Product Change Notification (PCN)

PCN Number: PCN_IndLFSMD_20260905 Affected Series: WE-LF SMD Affected Part Number: see table "PART NUMBER, REVISION & DATASHEET" PCN Date: 2026-06-05 (YYYY-MM-DD) Effective Date: 2026-09-05 (YYYY-MM-DD)	Change Category: ☐ Equipment/Location ☐ General Data ☒ Material ☐ Process ☒ Product Design ☐ Shipping/Packaging ☐ Supplier ☐ Software
Contact: Product Management Phone: +49 (0) 7942 - 945 5001 Fax: +49 (0) 7942 - 945 5179 E-Mail: pcn.eisos@we-online.com	Datasheet Change: ☒ Yes ☐ No Attachment: ☐ Yes ☒ No

1.) Separator:

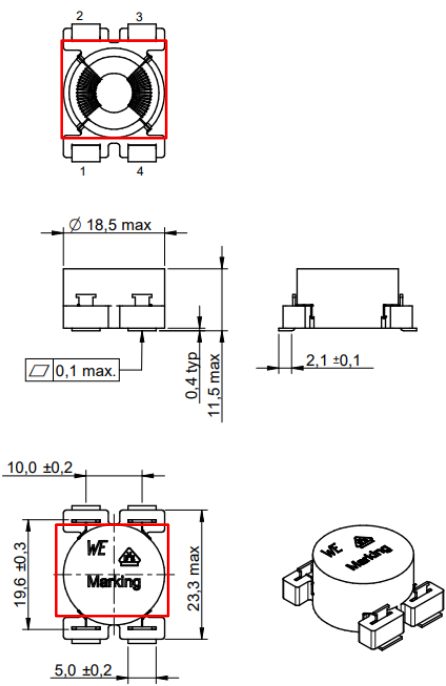
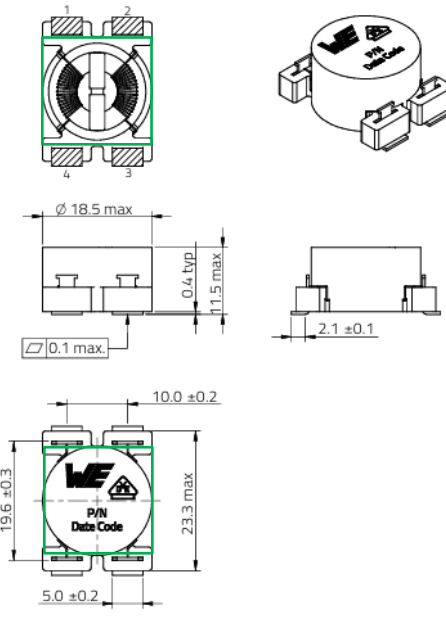
To enhance the product reliability, we will change the design and material of the separator between the windings. (See Before/After drawings below table)

2.) Electrical Test Condition of Inductance and Datasheet Correction:

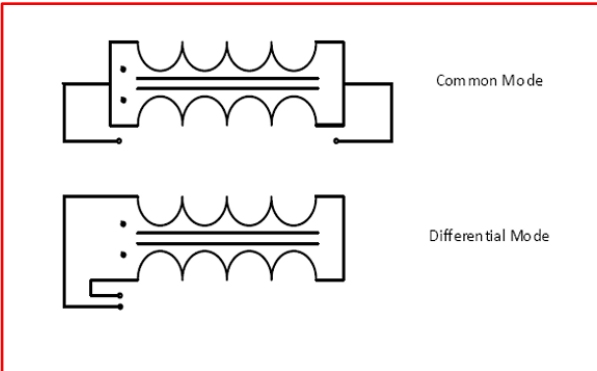
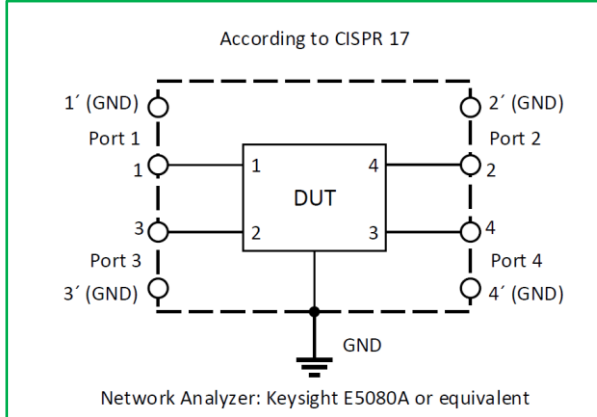
Because of a database mismatch, datasheet product drawing and test set-up for attenuation and impedance measurements will be corrected.

There will be no change on the measurements, only the pin numeration is corrected. Details are shown in the table below:
